Mirage DSK-8 Service Bulletins

For Mirage serial numbers 10001 - 14731

These service bulletins refer to the original Mirage DSK-8 Sampler.

FIGURE 7 — SHUGART SA500 DISK DRIVE

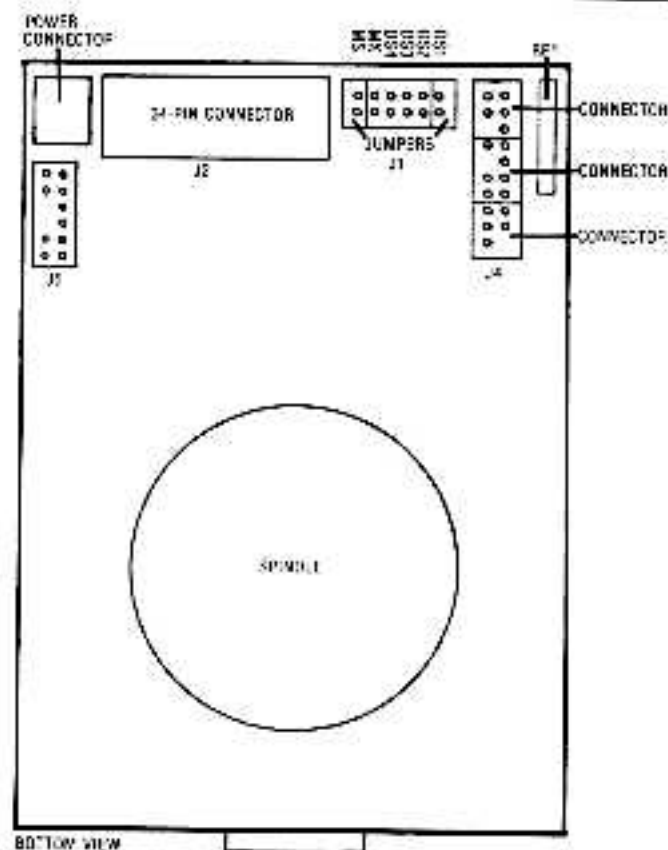
When you have narrowed down the diagnosis to a disk drive problem on Mirages equipped with Shugart Model SA500 drives, perform the following check before returning the drive to Ensoniq.

1. Remove the drive from the Mirage as per the instructions in SECTION D-1 . . . 4 of the Mirage Service Manual.
2. Orient the drive as shown in FIGURE 7.
3. Check the internal connectors of the disk drive at positions J4 and J5 (the J5 connector is one wiring harness while the J4 connector contains 3 separate wiring harnesses).
4. If you find that any of the connectors are not fully seated or completely off the terminals, reinstall the connectors, making sure that they are fully seated.
5. Reinstall the disk drive according to the instructions in SECTION D-5 . . . 8 of the Mirage Service Manual and test the unit.
6. If this procedure corrects the problem, then glue the connectors at J4 and J5 to the circuit board with hot glue.
7. If this procedure does not correct the problem, then the disk drive is bad. Remove the drive and return it to Ensoniq.

FIGURE B

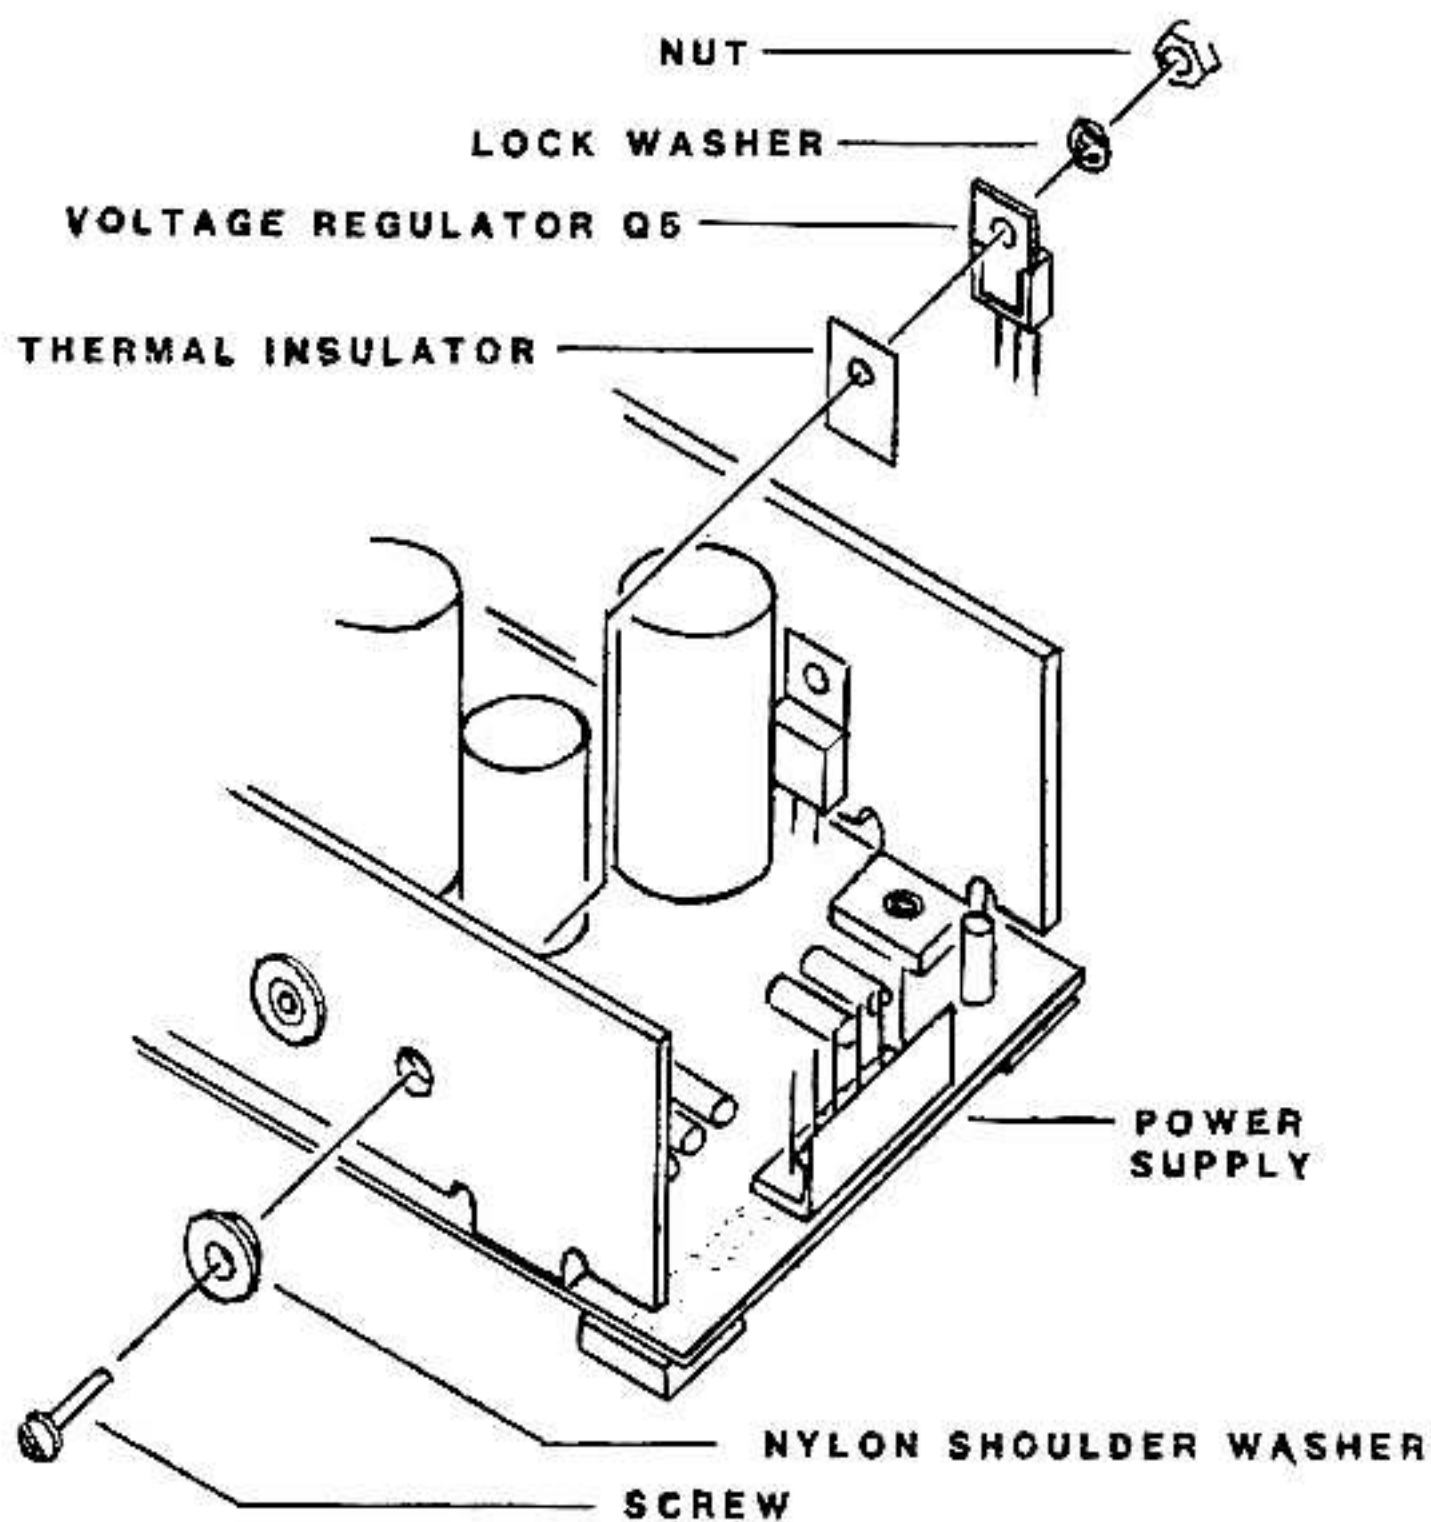
When you have narrowed down the diagnosis to warrant replacing the main board, always check the power supply for a +12V DC-8V DC voltage value. (Refer to Service Bulletin #1, section 5 to determine the power supply voltage value.) If the power supply does not have this voltage, it must either be replaced with a new power supply or modified (by changing one of the voltage regulators) in the following manner.

1. Follow the directions for removing the power supply in the Mirage Service Manual (section A1...4).
2. Using a drill with a 9/64" drill bit, drill out the rivet on the regulator marked Q5 (see Figure 8). This is the only one with a nylon shoulder washer on those power supplies which have 5 voltage regulators labelled Q1, Q2, Q3, Q4, Q5. The rivet should be drilled out from the side with the nylon shoulder washer.

3. Desolder the leads of voltage regulator Q5 and remove the regulator and the thermal insulator.
4. Insert the new voltage regulator (7908) in Q5 along with the nylon shoulder washer, the thermal insulator, the screw, nut and lockwasher as shown in figure 8.

5. Tighten the screw on regulator Q5.
6. Solder the leads of regulator Q5 on the bottom of the power supply.
7. Inspect for solder joints.
8. Replace the power supply as per the directions in the Mirage Service Manual (A5...6) and allow to burn-in for a few hours.

Chassis Configuration for Epson and Shugart Drives

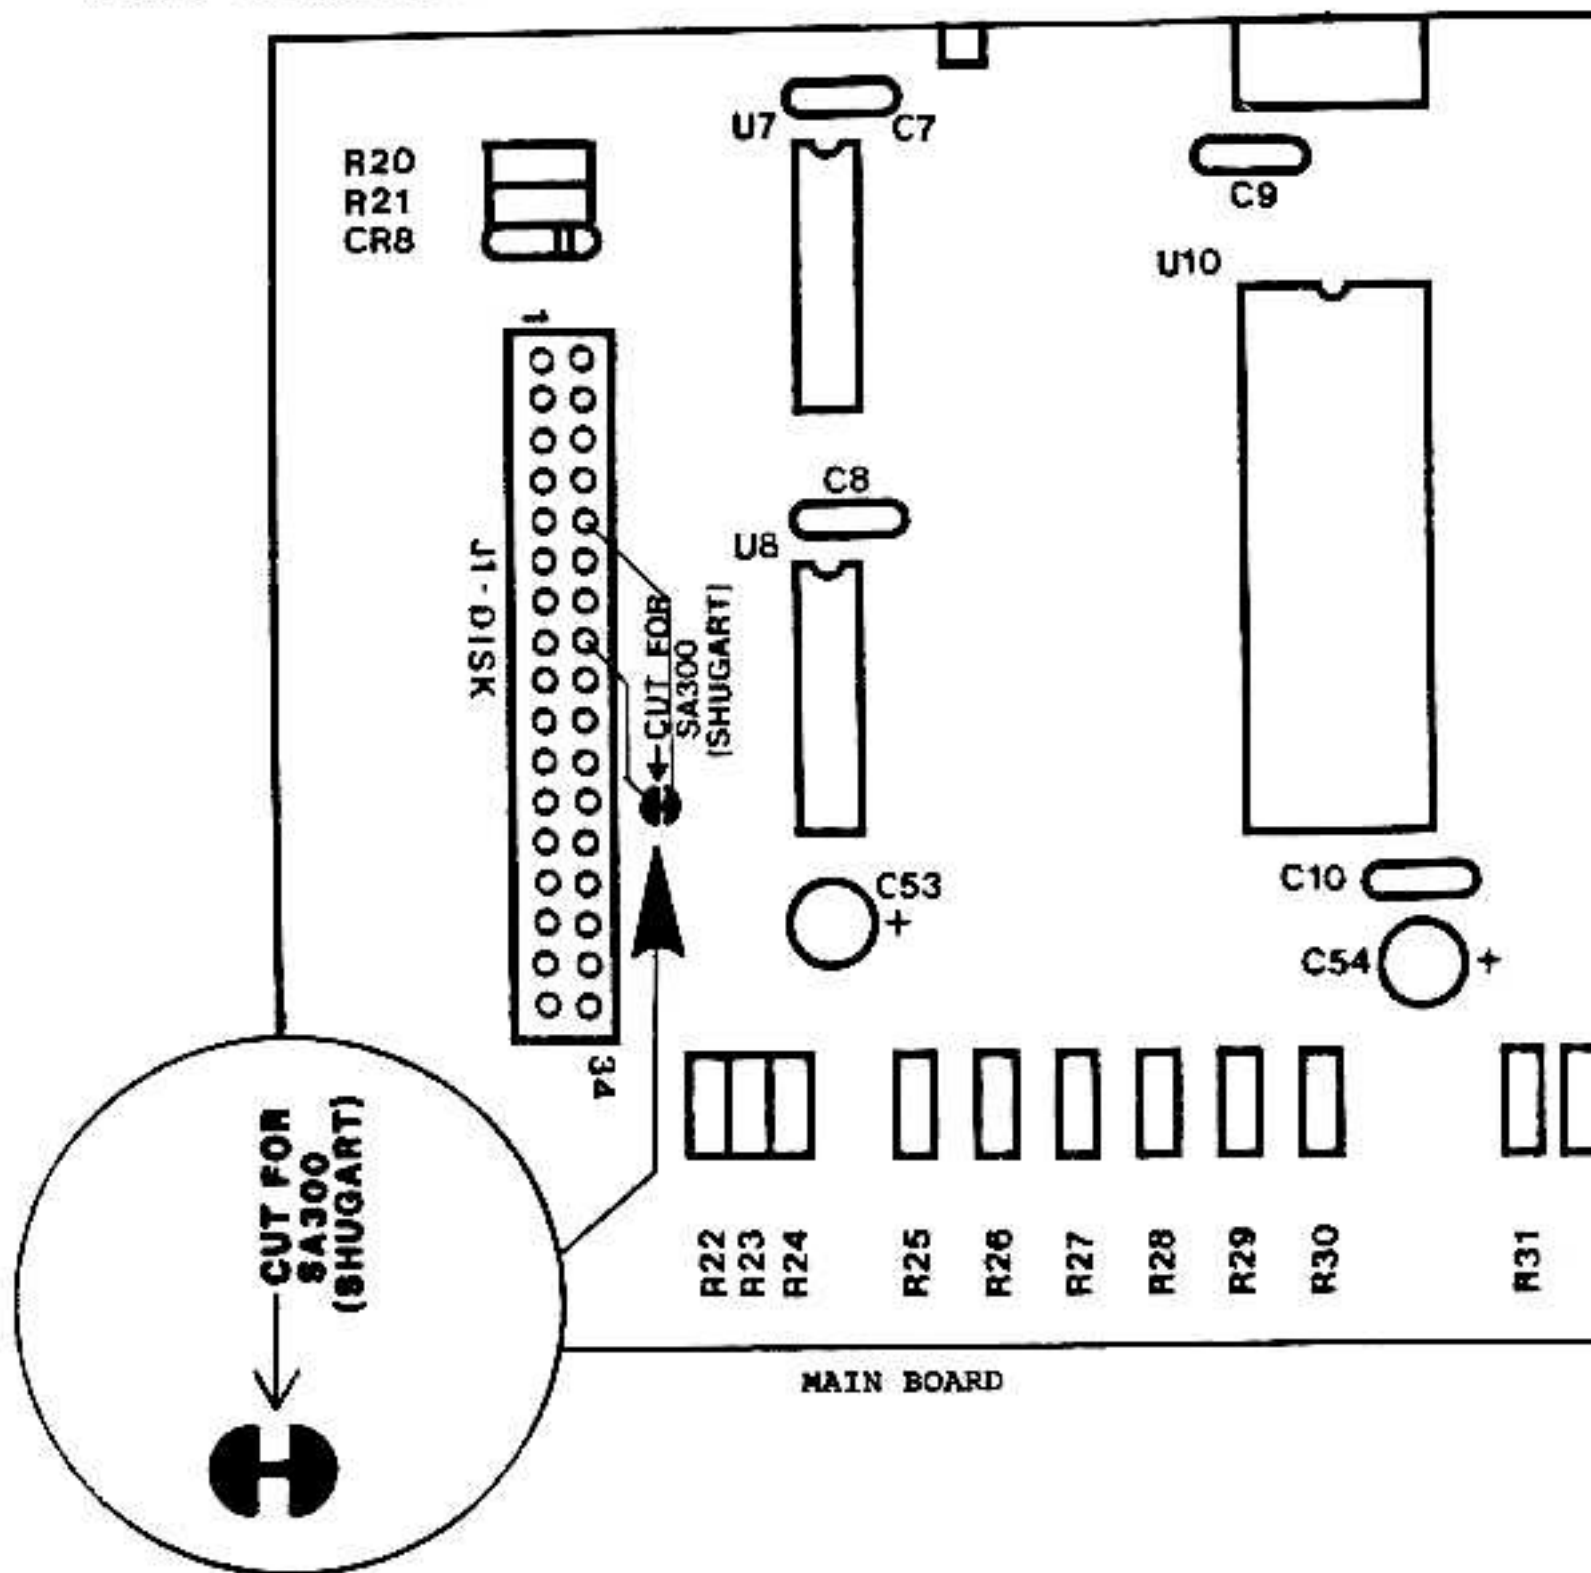
When you have narrowed down the diagnosis to warrant replacing the main board, always check to see which disk drive is being used. The Mirage uses both Epson and Shugart drives. These drives differ physically and in their compatability with the main board.

Epson: The disk eject button is located on the lower right of the drive front panel and the 4 pin power connector is located to the left of the ribbon cable at the rear of the drive. On the **main board** a jumper must be shorted at disk drive connector J1 (by shorting this jumper, pins 10 & 16 will be connected).

Shugart: The disk eject button is located in the center of the drive front panel and the 4 pin power connector is located to the right of the ribbon cable at the rear of the drive. On the **main board** a jumper must be out at disk drive connector J1 (by cutting this jumper, pins 10 & 16 will **not** be connected).

Each chassis is specifically designed for either an Epson or Shugart drive. These drives are not interchangeable within the same chassis.

The jumper should be cut with a Xacto-Knife (or equivalent) as per instructions in the blow-up of the Disk Drive selector jumper on the other side of this bulletin.

Make the cut on this thin trace that runs between the two pads for the disk drive selector jumper. If the trace is cut at both ends where they connect to each pad it can be peeled off the circuit board. Using a xacto knife (or equivalent type of knife). This will yield a clean jumper cut and will leave the solder pads intact for future reconnection.

TRIMPOT ADJUSTMENT ON MAIN BOARD

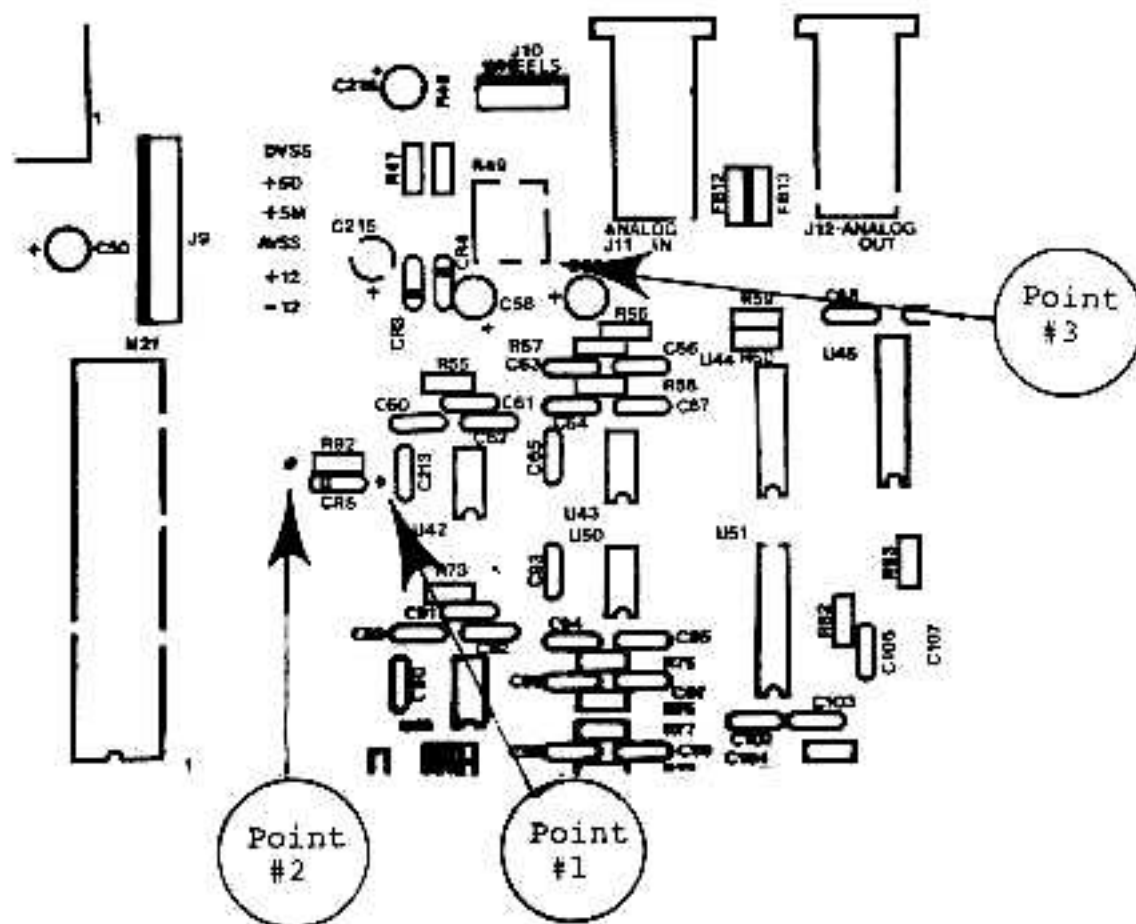
When replacing the Mirage Main Board or the Mirage Power Supply, careful attention must be given to re-adjusting the trimpot located at R49 (Point #3) on the main board. This trimpot sets the volume reference voltage going into the "Q" chip (U21) and if it is not set properly, audio distortion is likely to occur. R49 is located in the upper right hand side of the board, to the left of the Analog-In jack (J11) and directly below the Pitch/Mod Wheel connector, (J10).

The voltage reference point can be accessed by placing the positive probe of your meter on the right lead of CR5, a diode located on the lower right of R92, (point #1). Place the negative probe to Ground, the left lead of R92 (point #2). Adjust the trimpot (point #3) until the meter reads 50 millivolts, or .050 VDC.

3A

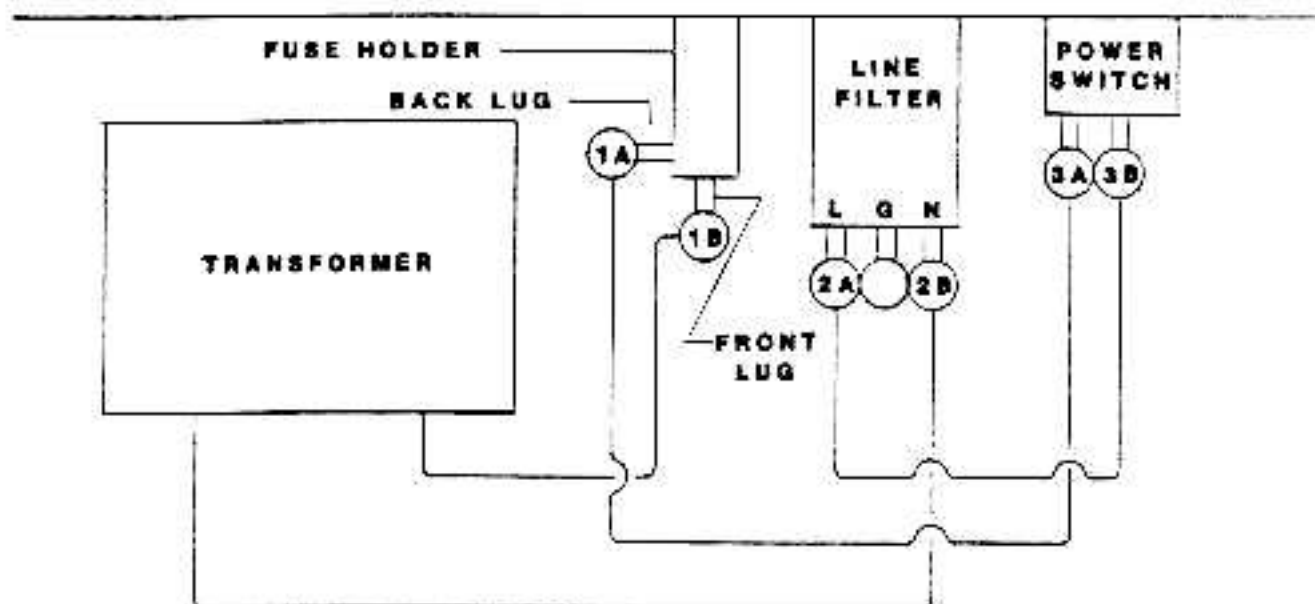
THIS BULLETIN CORRECTS FIGURES 3A AND 3B OF THE SERVICE MANUAL

AC LINE VOLTAGE CHECK POINTS
WIRING FOR EARLY MODEL CASE (WHERE TRANSFORMER IS ON THE LEFT).

3B

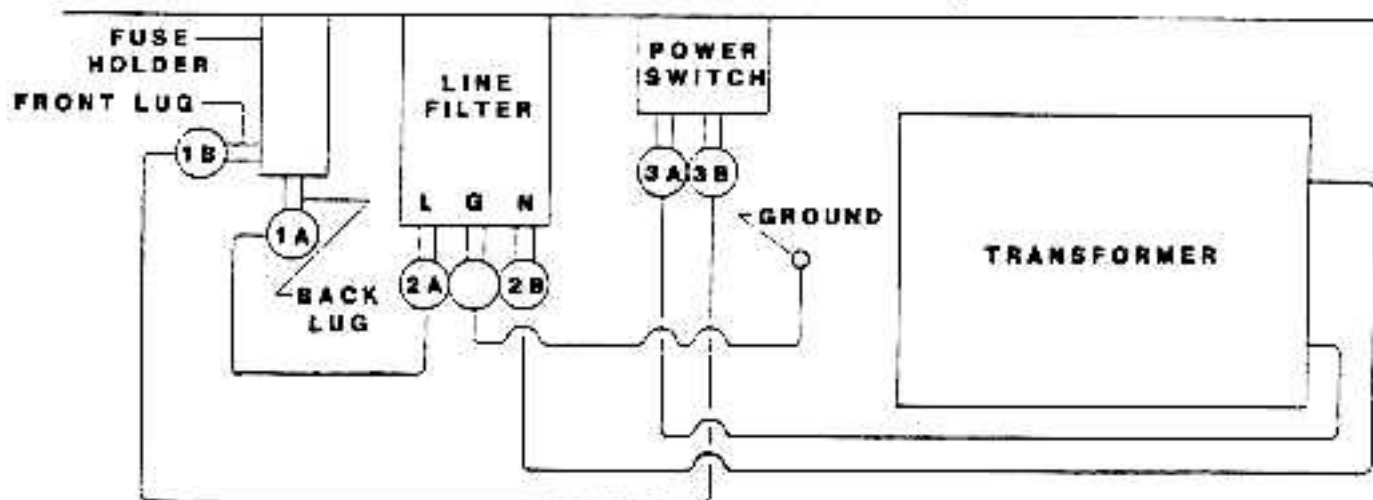
AC LINE VOLTAGE CHECK POINTS
WIRING FOR LATE MODEL CASE (WHERE TRANSFORMER IS ON THE RIGHT).
